New Bid Date and Time 3:00 PM, Wednesday, May 30, 2012

ADDENDUM 2

Project Name: **Hale Stadium Renovations
Tennessee State University**
Owner: **Tennessee Board of Regents**
Address: **Office of Facilities Development
Suite 664 (6th Floor, southwest) Genesco Office Park
1415 Murfreesboro Road
Nashville, TN 37217-2833**
City, State:
Project Number **SBC #166/002-02-2011
HFR# 2011171.00**
Date: **May 18, 2012**
From: **HFR Design, Inc.
7101 Executive Center Drive, Suite 300
Brentwood, TN 37027**

C4.04

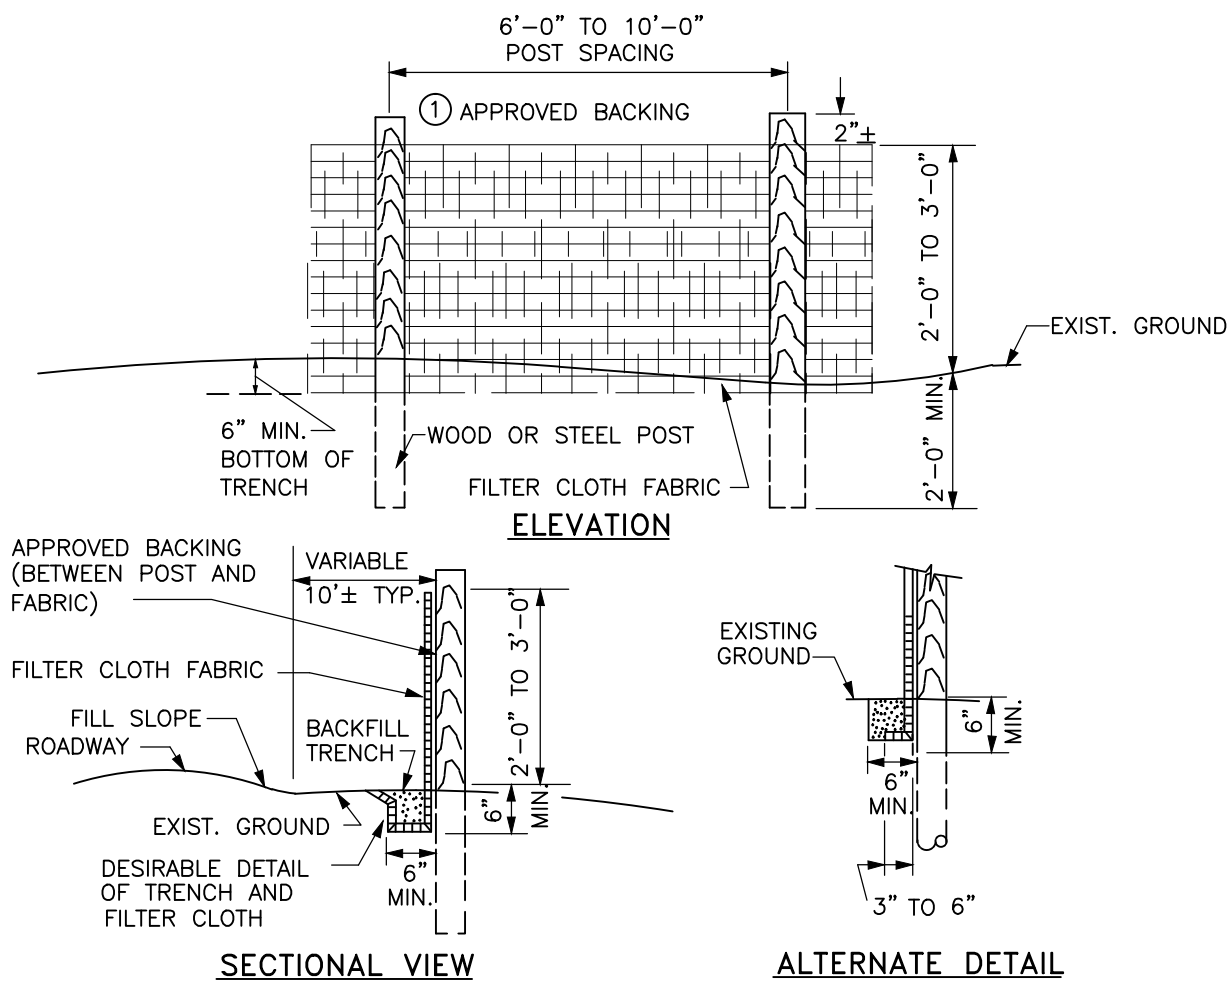
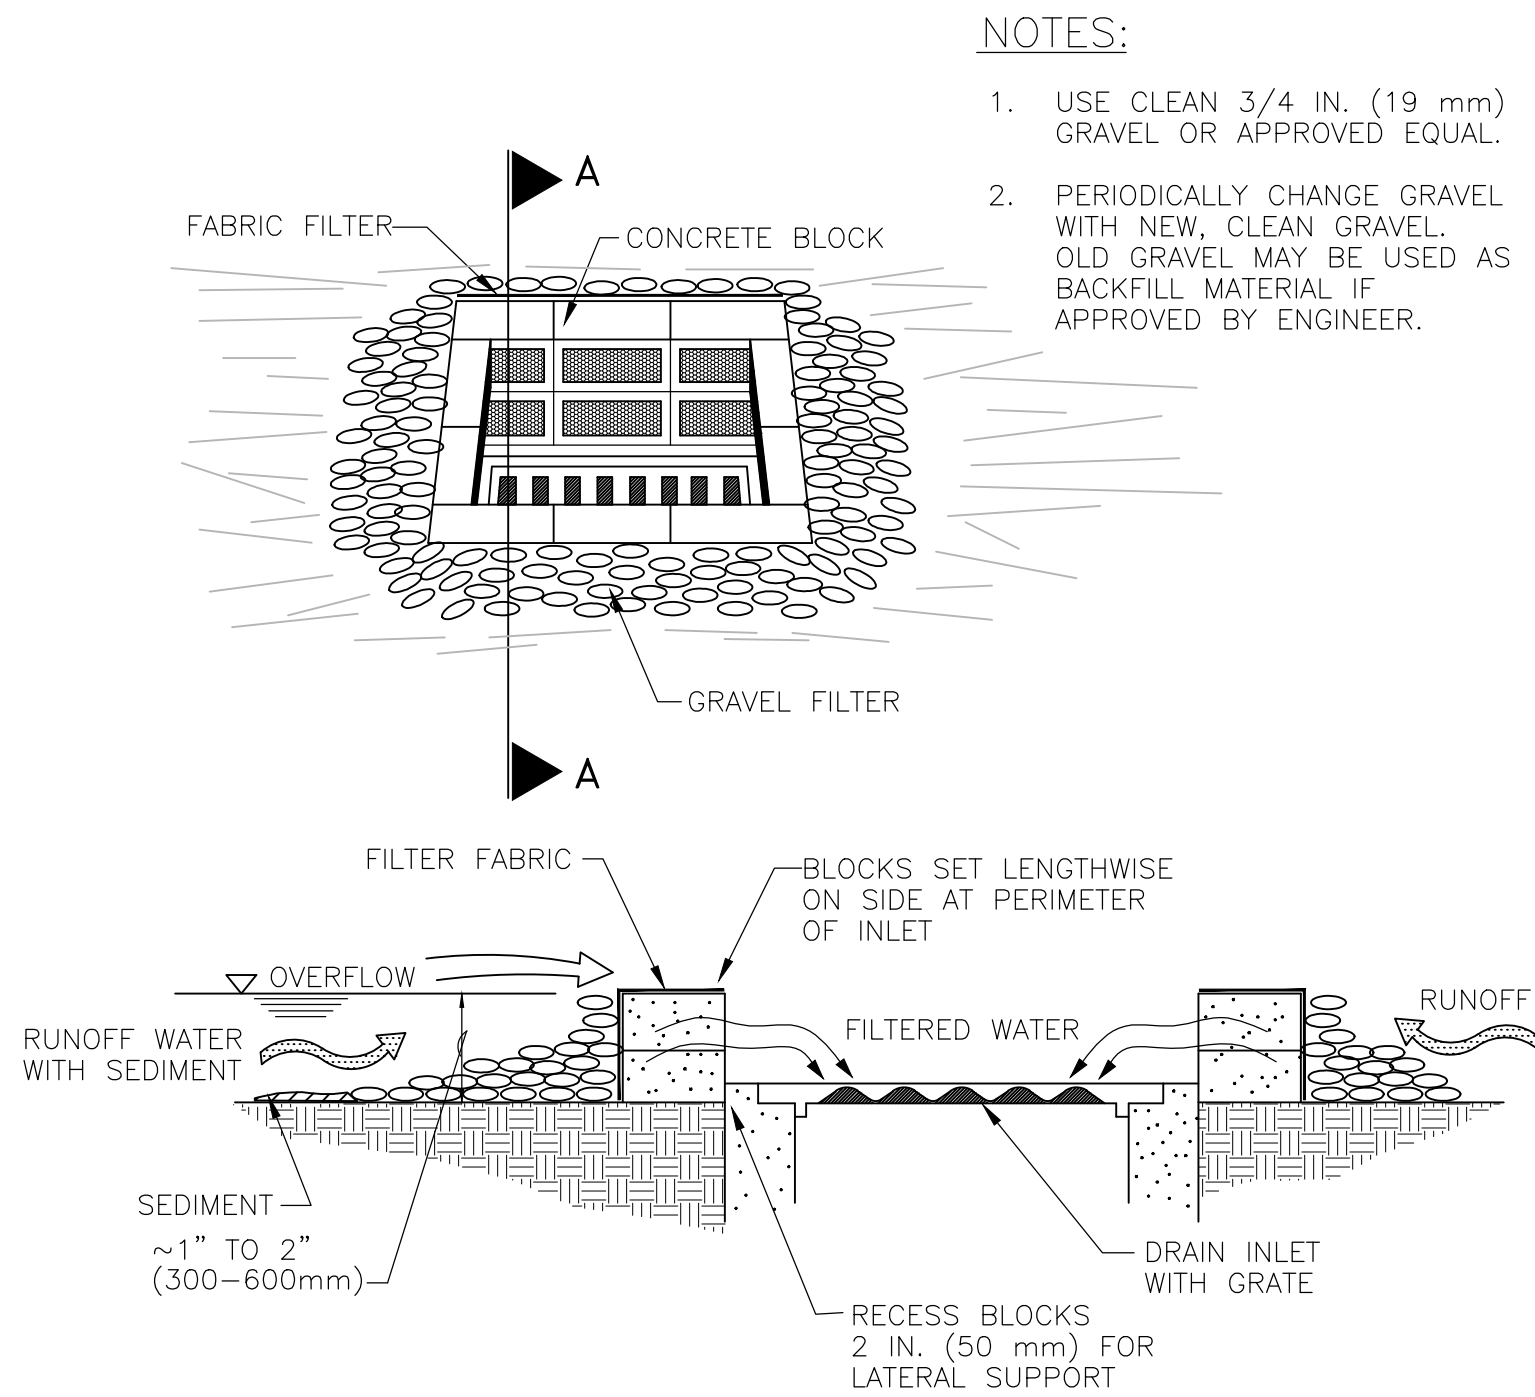
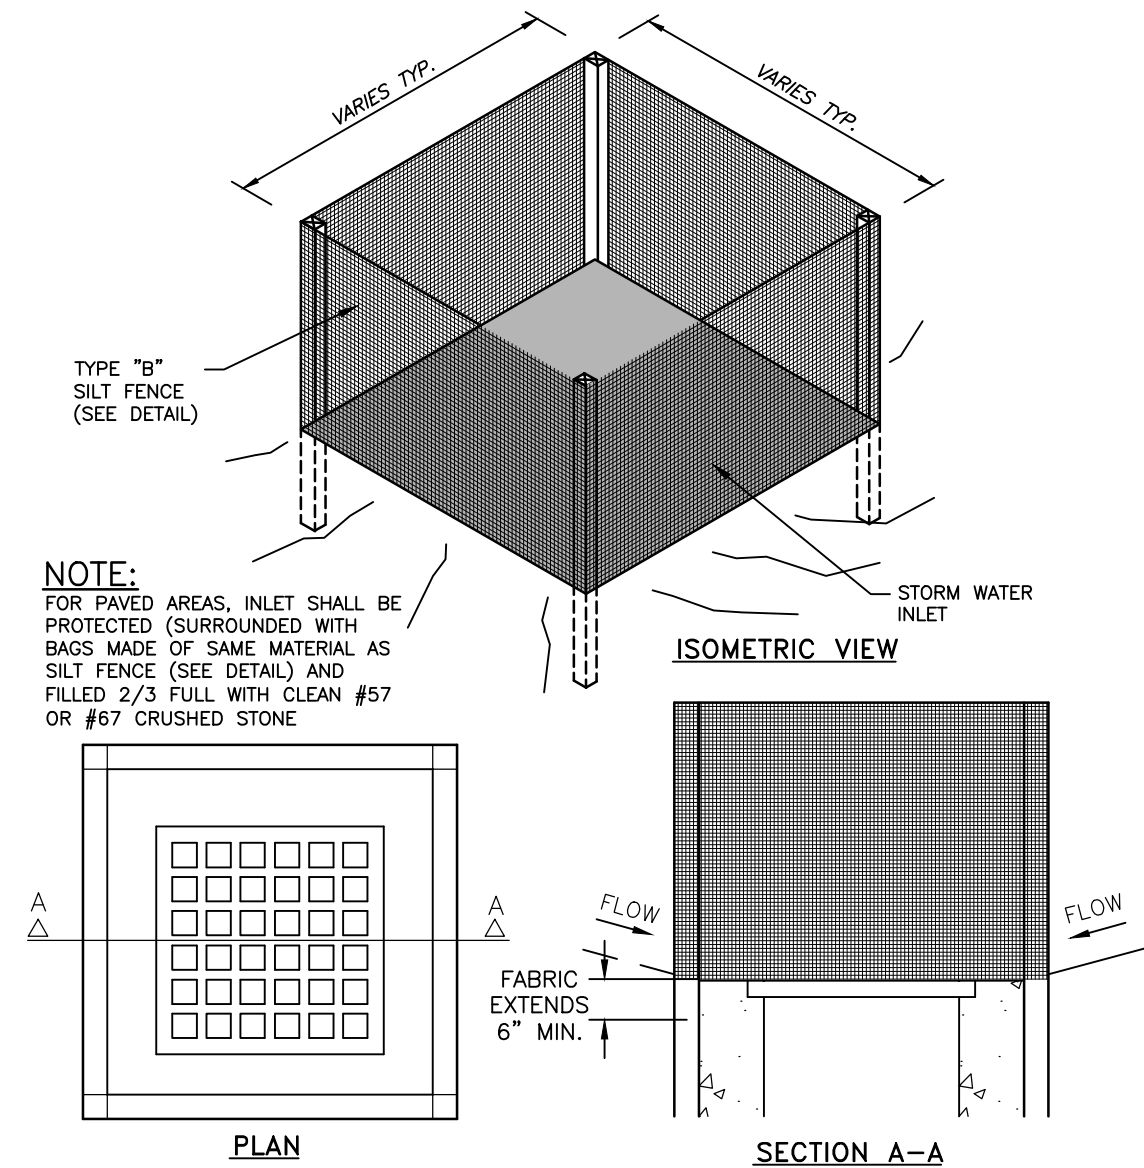
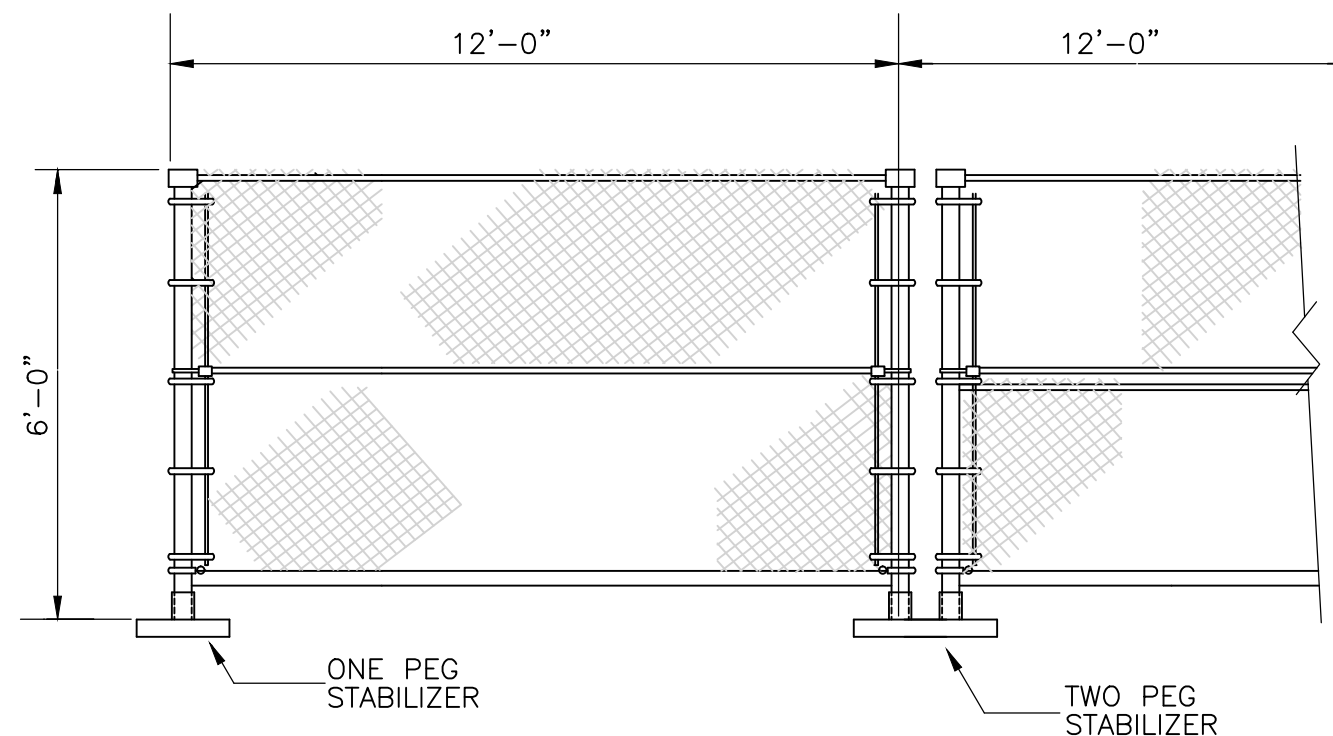
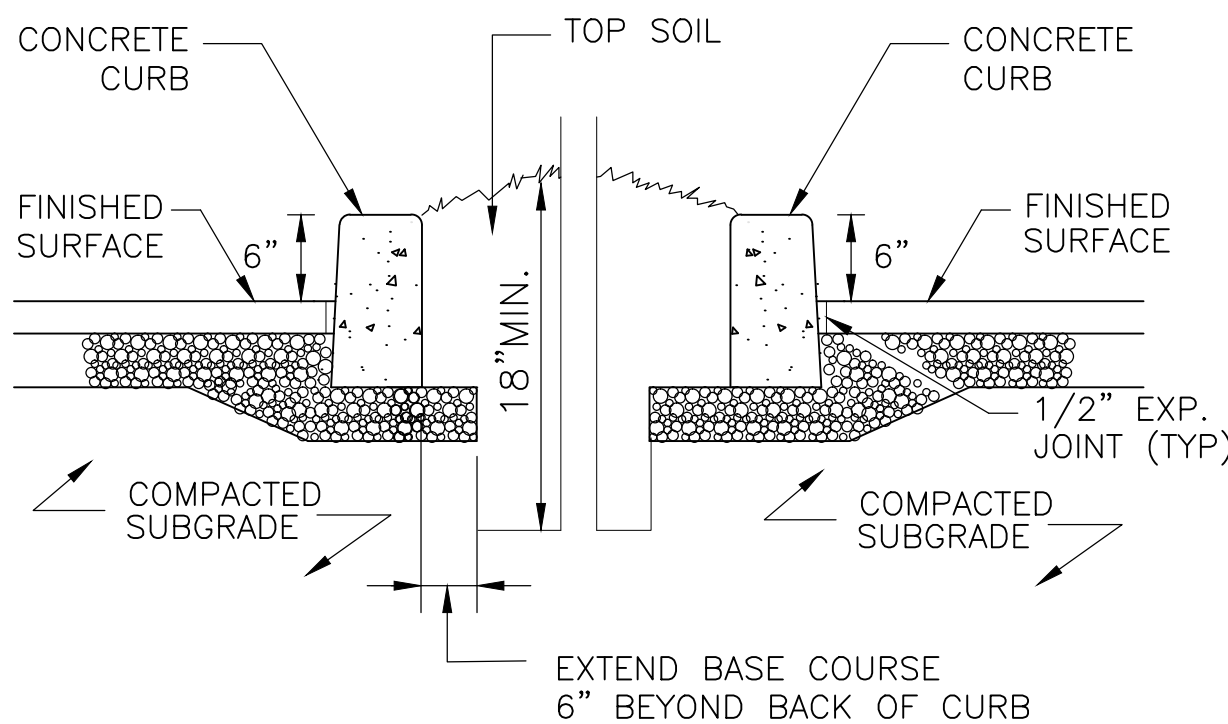
- 2-23. Drawing C4.03: Deleted detail for gate and replaced with detail for fence post with chain.
- 2-24. Drawing C4.04: Added detail for temporary construction entrance.
